APPLICATION NO.	FILING DATE	FIRST NAMED INVENTOR	ATTORNEY DOCKET NO.	CONFIRMATION NO.
09/545,834	04/10/2000	Shuhie Harada	Q58793	3167

Office Action Summary

DETAILED ACTION

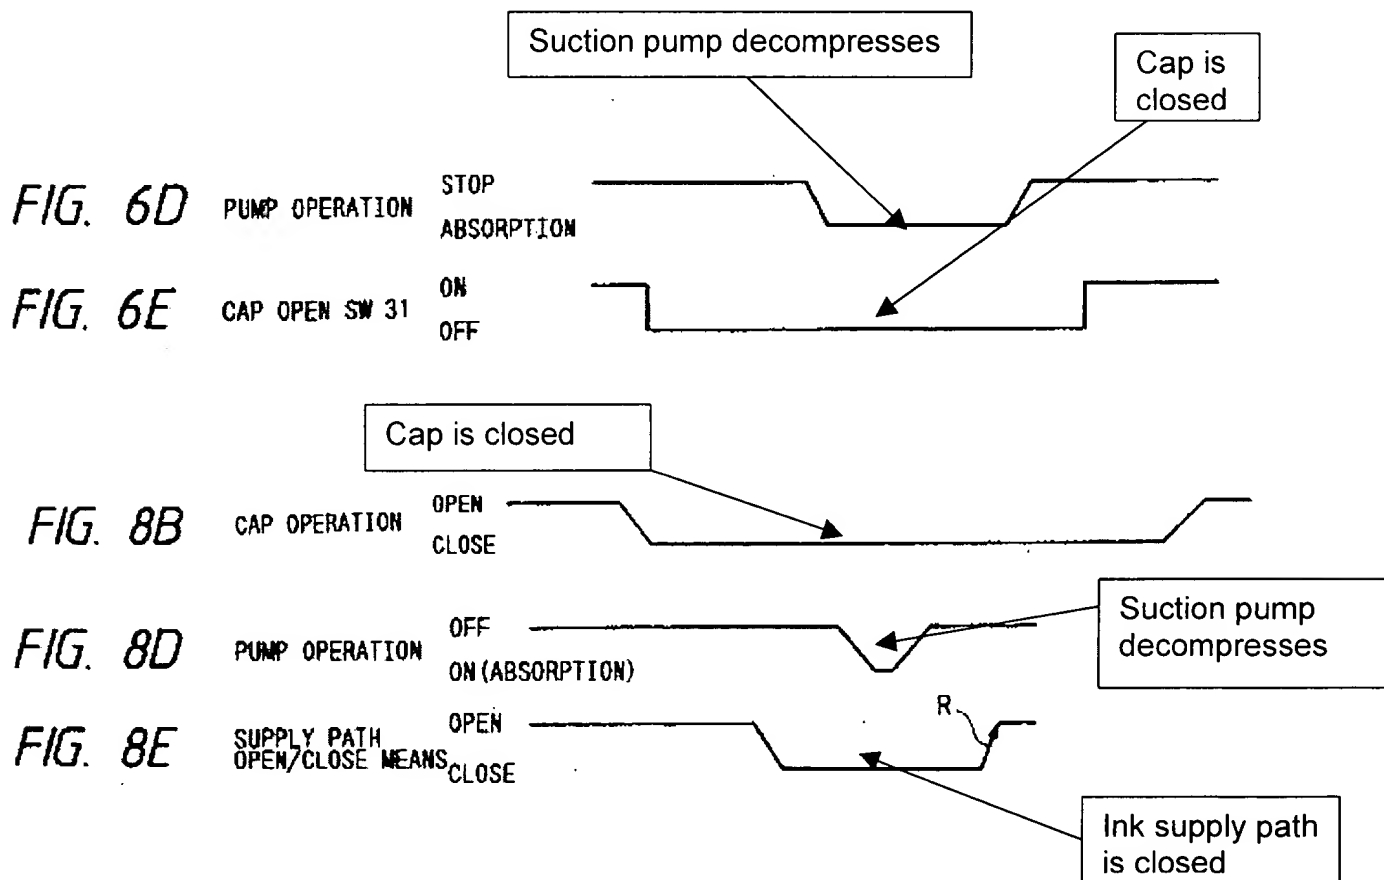
- The capping unit such that the decompresses state of the internal space of the capping unit is maintained while the suction pump is driven (Fig.6D-6E)
- The suction pump continues decompressing the internal space of the capping unit for a second predetermined time period (Fig.6C+6D);

With respect to claim 71, Terasawa et al. discloses the step of stopping to drive the suction pump after a second predetermined time period has elapsed since the ink flow passage was opened (Fig.6C-6D).

With respect to claim 72, Terasawa et al. discloses the step of driving the suction pump between the sealing step and the closing step (Fig.6C-6E).

With respect to claim 73, Terasawa et al. discloses the step of driving the suction pump again after the stopping step has executed (Fig.6D).

With respect to claim 74, Terasawa et al. discloses step of releasing the capping unit from the nozzle orifices after the suction pump has driven again and driving the

suction pump again to discharge ink from the nozzle orifices in a capping released state (Fig.6D-6E).

Applicant's argument that Terasawa et al. does not teach the controller controls the capping unit such that the decompressed state of the internal space of the capping unit maintained while the suction pump is driven is not persuasive. Refer to figure 6D and 6E, clearly shows that the cap is closed when the pump is operated.

**FIG. 1****FIG. 2**

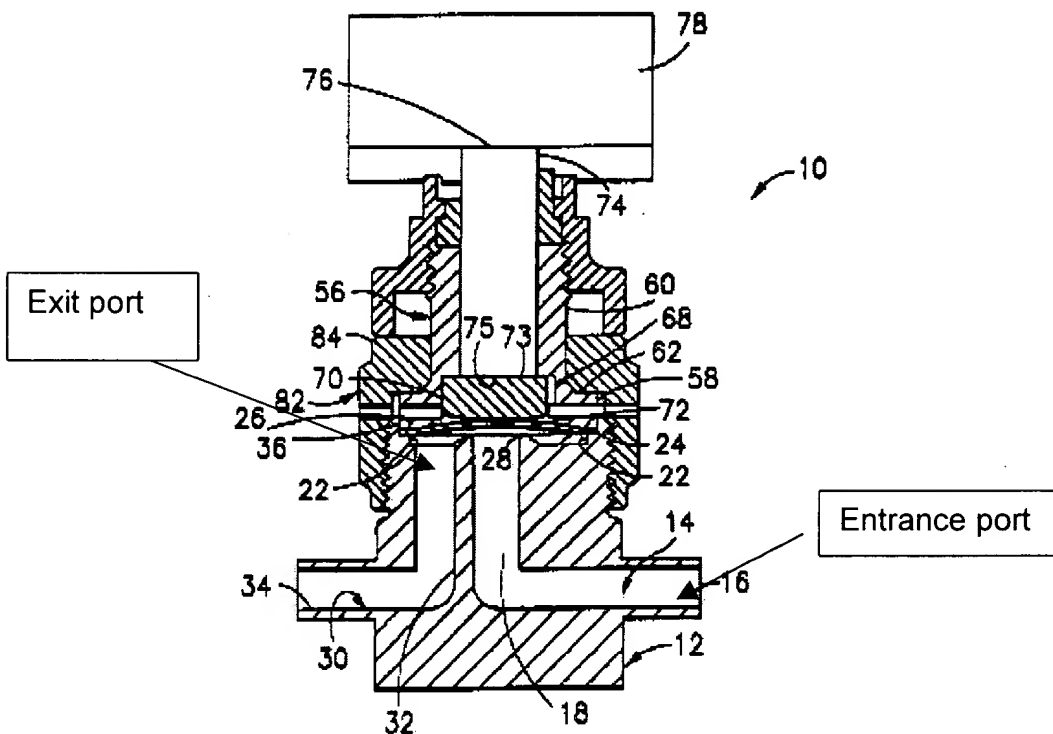
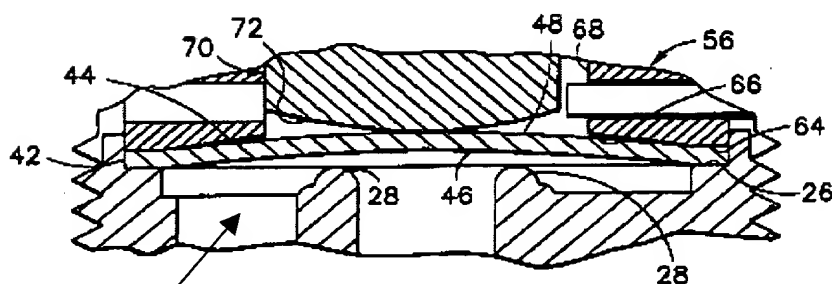
Wu et al. teaches a valve control chamber (fig.1: element 20), a flexible diaphragm (Fig.3: element 40), an actuation body (Fig.1: element 74+78), valve control chamber has an entrance port formed on a top wall thereof at a portion where is away from the center portion of the diaphragm and an exit port formed on the top wall (Fig.1), the entrance port is arranged below the exit port (Fig.1), the circumferential portion of the exit port is tapered (Fig. 2), the diaphragm includes an annular convex portion (Fig. 2: element 48) and the actuation body is a rod member (Fig. 1: element 70+74).

Exit port is tapered (larger on the top and smaller on the bottom)
